Alternative optical Tx eye-mask for 10GBASE-R modules (Clause 52)

18th July 2011

Jonathan King

Proposal

Why: The optical Tx eye-mask test issue 1

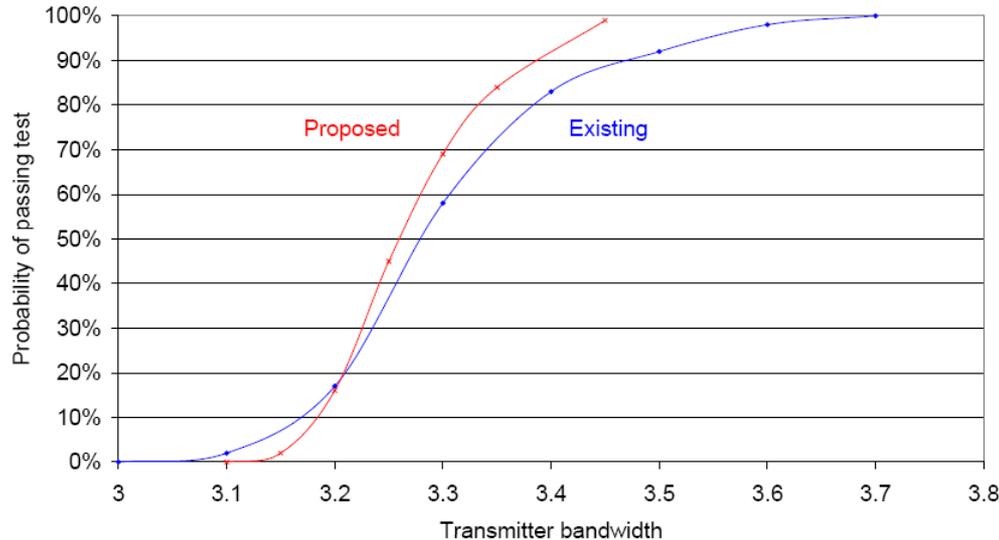
- The current optical transmitter eye-mask test for 10GBASE-R optical transmitters is commonly implemented as a zero hit eye-mask test.
- A zero hit eye-mask test has a several drawbacks
 - Eye mask margin is determined by a single rare event – poor repeatability
 - Eye-mask measurements by different parties are difficult to correlate
 - Larger numbers of samples make the test even less repeatable !
- The single hit criterion causes a large range in device performance between all-passing and all-failing. Failing good devices adds cost.

Measurements

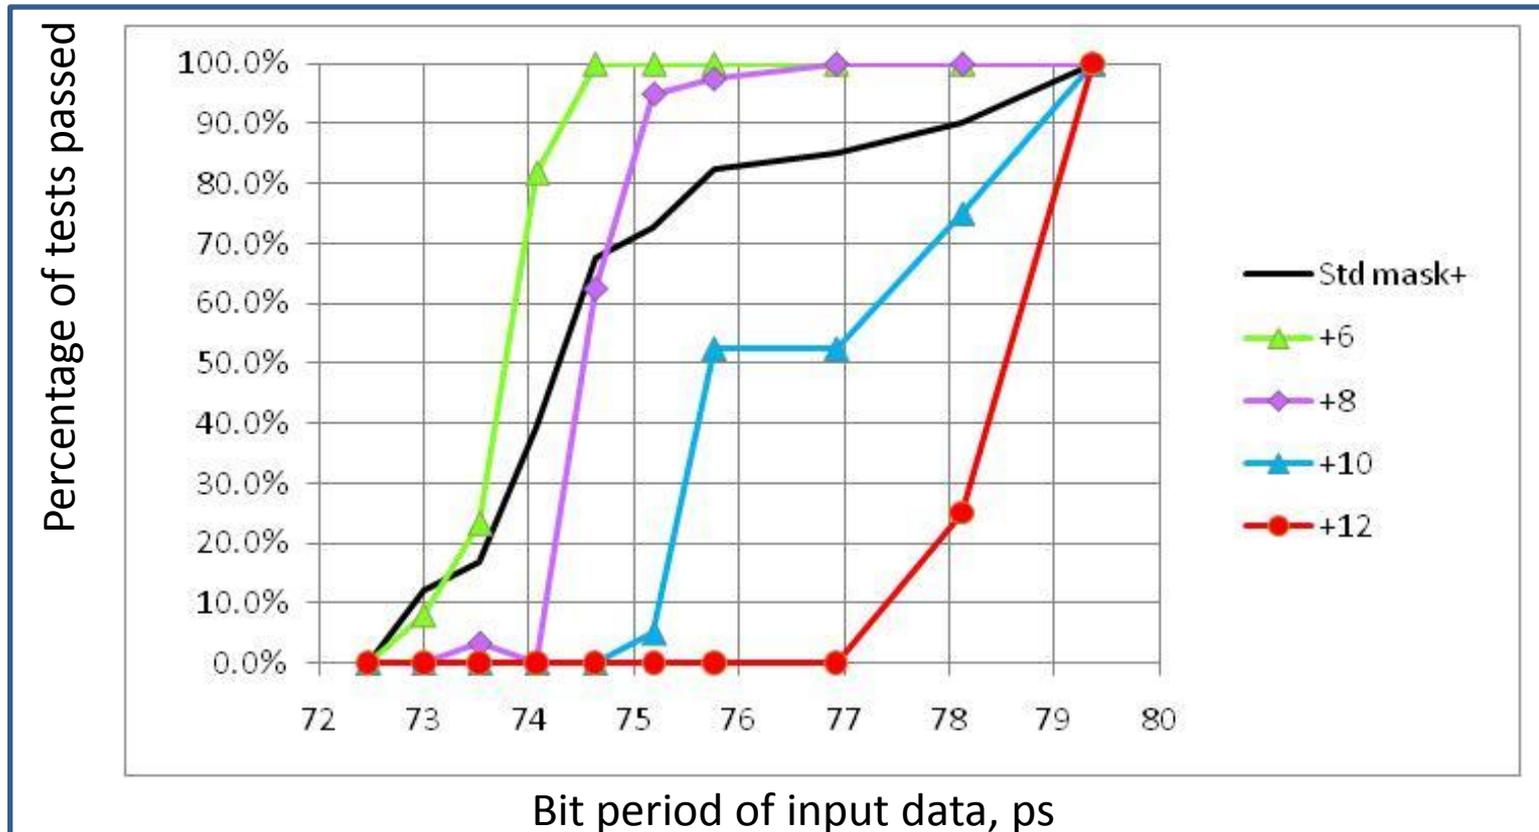
- A comparison of pass/fail rates for transmitter eye mask tests was made:
 - the 10GBASE-R standard zero-hit eye mask from clause 52 and
 - a set of test eye masks scaled from the clause 52 mask coordinates, with max hit ratio of $5e-5$
 - + 6%, +8%, +10%, +12%
- A total of approx 1800 mask measurements were made using a typical SFP+ 10G SR compliant module. 500,000 samples / UI were taken, allowing up to 25 hits in the mask area for a hit ratio $\leq 5 \times 10^{-5}$
- In order to produce a marginal transmitter eye, the input data rate to the module was increased to between 12.8 GHz and 13.8 GHz. The resulting transmit eye has greater jitter and ISI. Eye mask coordinates were scaled with bit rate and eye height, per standard procedure.

- The eye mask coordinates and the measured results for the +6% eye mask agree very closely with the simulations in Pete Anslow's '10GBASE-S/L/E eye mask': the clause 52 eye mask and the +6% eye mask have ~15% pass rate at the same input data bit period.
- All the hit ratio masks have significantly steeper slopes (better discrimination between good and bad transmitters) than the 0 hit eye mask
